IEEE P802.3az/D1.0 Clause 55 PHY Wake Time

Mike Grimwood, Broadcom

IEEE P802.3az Task Force
Dallas, November 2008

Worst-case Wake Time Scenario – Wake from Sleep

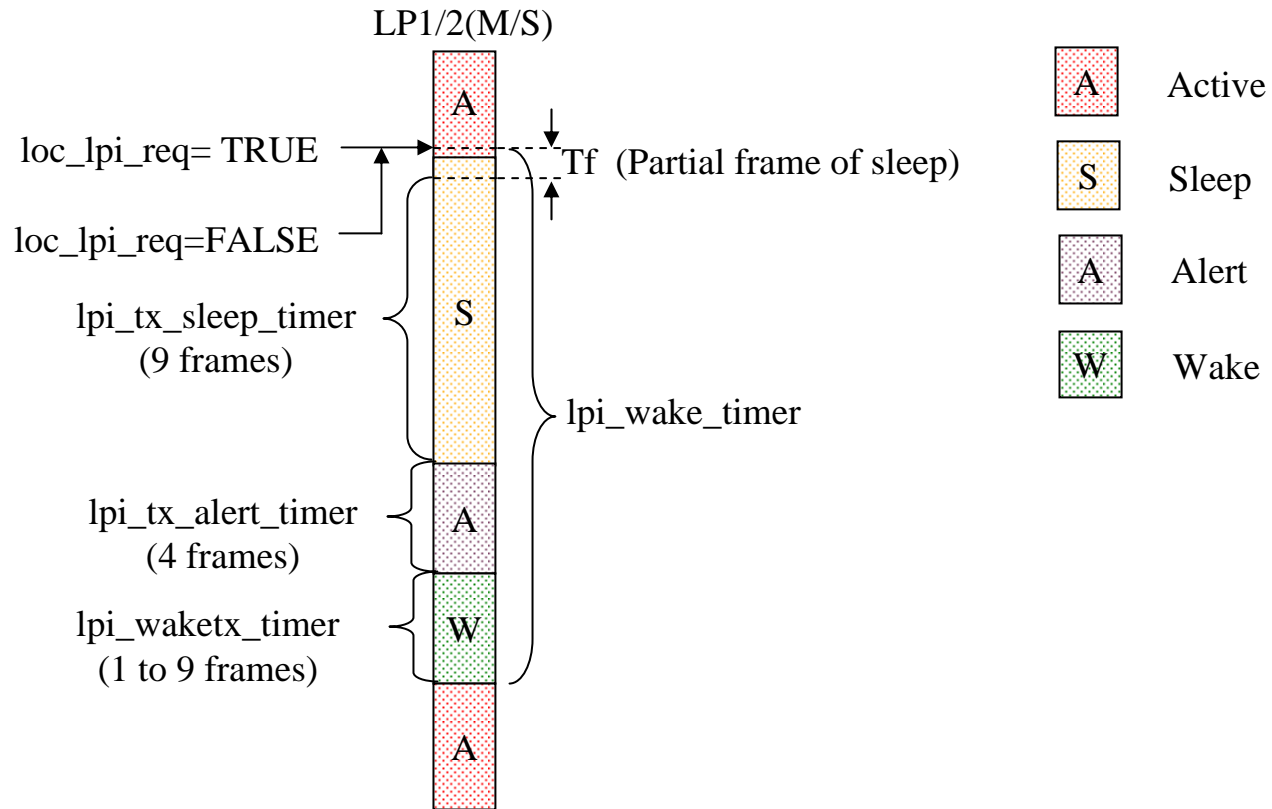
- IEEE P802.3az/D1.0 does not specify an explicit overall maximum PHY wake time value for 10GBASE-T EEE (i.e. T_{w_phy} as defined in Clause 78).
- Instead, there is an lpi_wake_time negotiated in the range of 1 to 9 frames.
- The related T_{w_phy} time and associated requirement needs to be explicit to ensure implementations meet this overall PHY wake time.
- This presentation proposes the worst-case PHY wake time with the intent of providing a requirement for inclusion in the next draft.

- In Clause 55, create timer *lpi_wake_timer* (consistent with *Tw_phy* for 1000BASE-T EEE).
- Replace *lpi_wake_period* and *lpi_wake_time* with *lpi_waketx_time*.
- Replace *lpi_tx_phy_wake_timer* with *lpi_waketx_timer*.
- Specify that *lpi_waketx_time* is chosen from 1, 3, 5, 7 or 9 PHY frames.
- Insert table from previous slide with reduced set of *lpi_waketx_time* values and associated *lpi_wake_timer* values.
